# UNITED STATES PATENT AND TRADEMARK OFFICE

| APPLICATION NO. | FILING DATE | FIRST NAMED INVENTOR | ATTORNEY DOCKET NO. | CONFIRMATION NO. |
|-----------------|-------------|----------------------|---------------------|------------------|
| 10/589,806      | 05/23/2007  | Lars Schumann        | 095309.58115US      | 2420             |

| <b>Office Action Summary</b> | <b>Application No.</b><br>10/589,806 | <b>Applicant(s)</b><br>SCHUMANN, LARS |  |

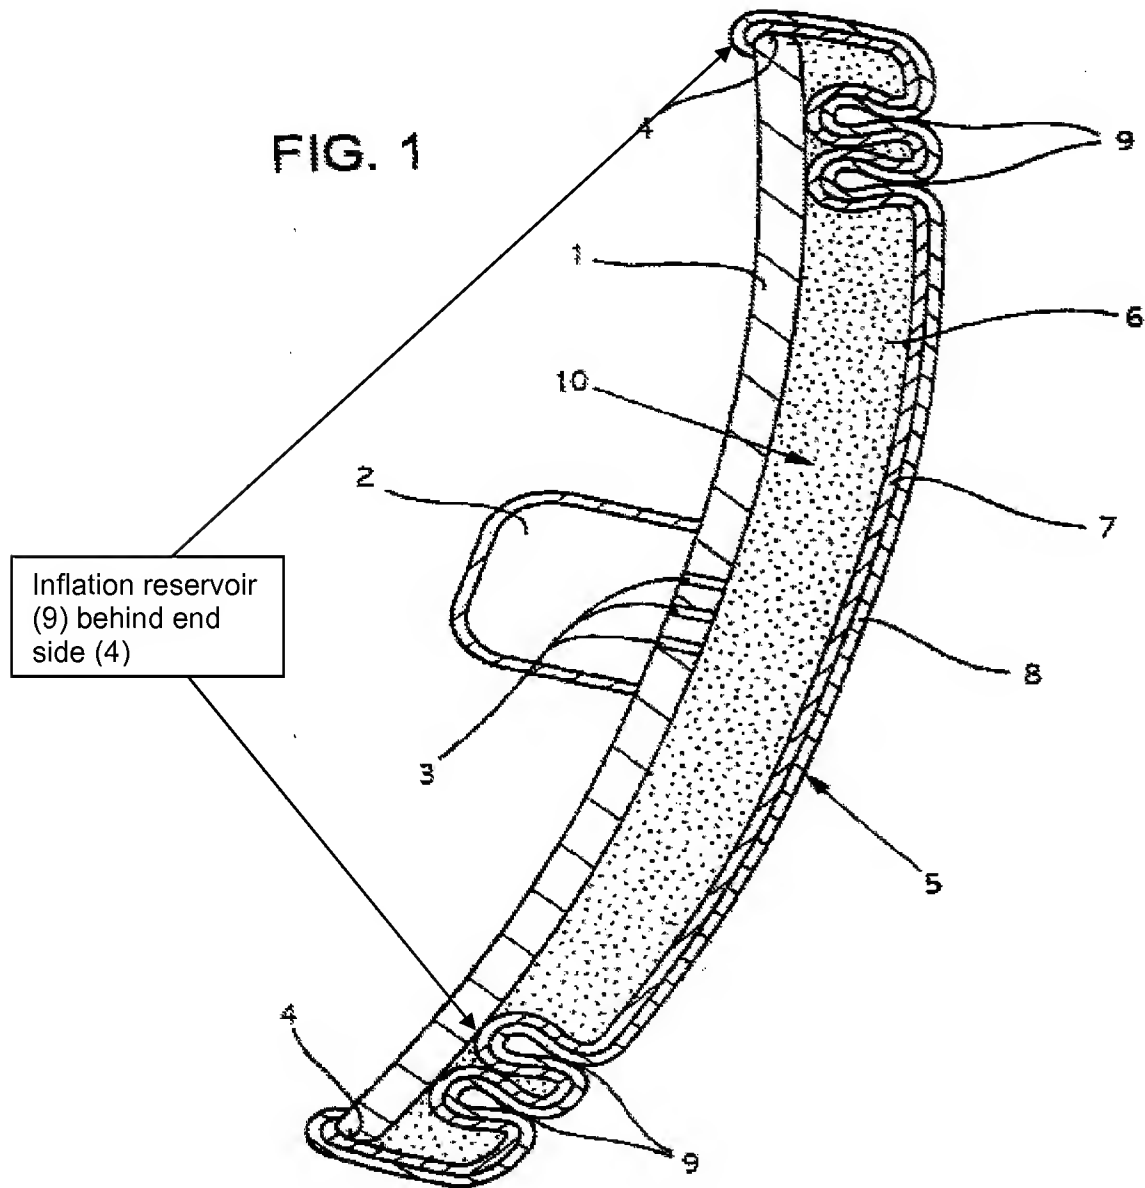
8. Claims 10-12, 14-17, 19-20, 22-23, and 28-29 are rejected under 35 U.S.C. 102(b) as being anticipated by Tietz (DE 10123207), as applicant admitted prior art.

With respect to claims 10-12 and 28-29, Tietz discloses an airbag cover (5) on an end side (4) of the basic body (1) facing the vehicle occupant (Fig. 1), bearing directly against the basic body (1) and engaging around at least one edge (4) of the end side. (Figs. 1-2.) Tietz further discloses an inflation reservoir (9) provided for the airbag cover (5), wherein the inflation reservoir (9) is arranged behind the end side (4) of the basic body (1). (Modified - Fig. 1 below.) Tietz further discloses the basic body (1), together with the inflatable airbag cushion (10 and 6), forming a separate module. (Fig. 1.) Tietz

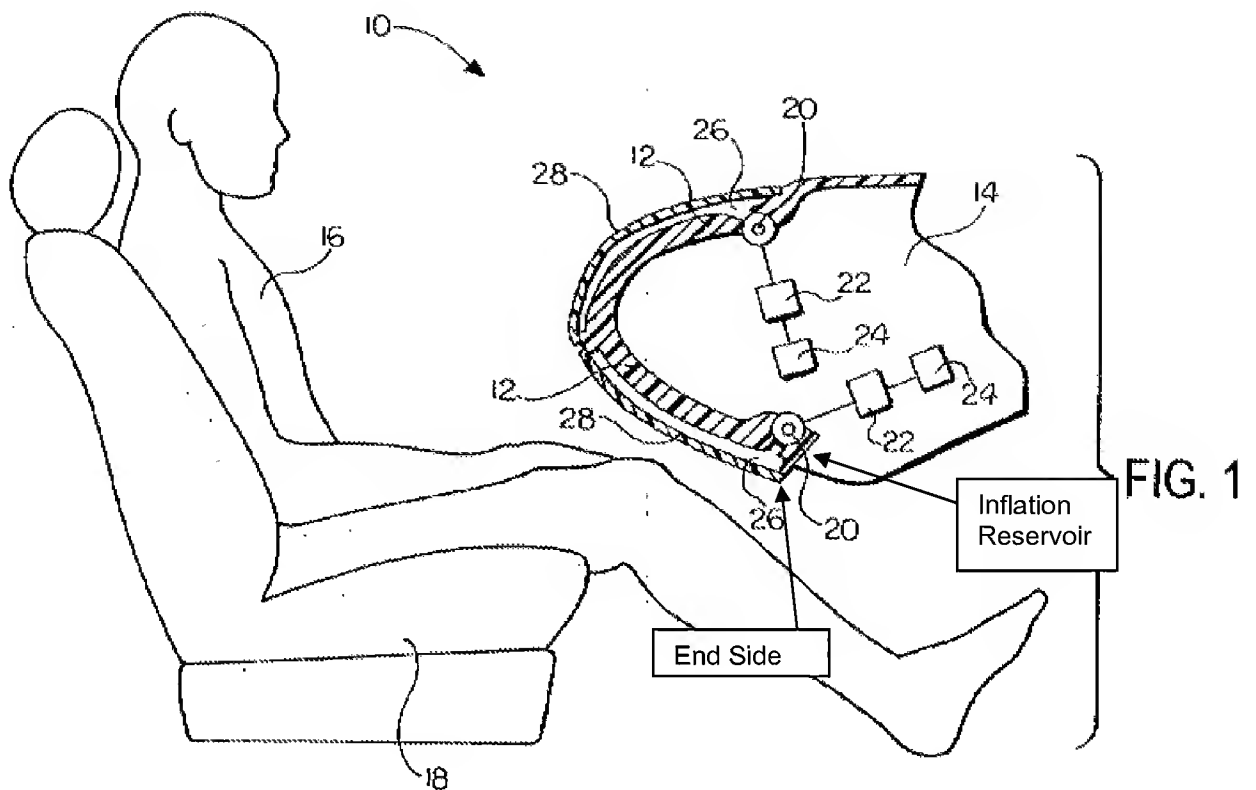
9. Claims 10-14 and 16-29 are rejected under 35 U.S.C. 102(b) as being anticipated by DePue et al. (US Pub. No. 2004/0100080 A1).

With respect to claim 10, DePue et al. discloses an airbag cover (“expandable skin” - 28) for protecting vehicle occupants against injuries during accidents, the airbag cover (28), on an end side of the basic body (“housing” - 12) facing the vehicle occupant, bearing directly against the basic body (12) and engaging around at least one edge of the end side. (Modified Fig. 1 – below.) DePue et al. further discloses an inflation reservoir for the airbag cover (28), which is arranged behind the end side of the basic body. (Modified Fig. 1 – below.)
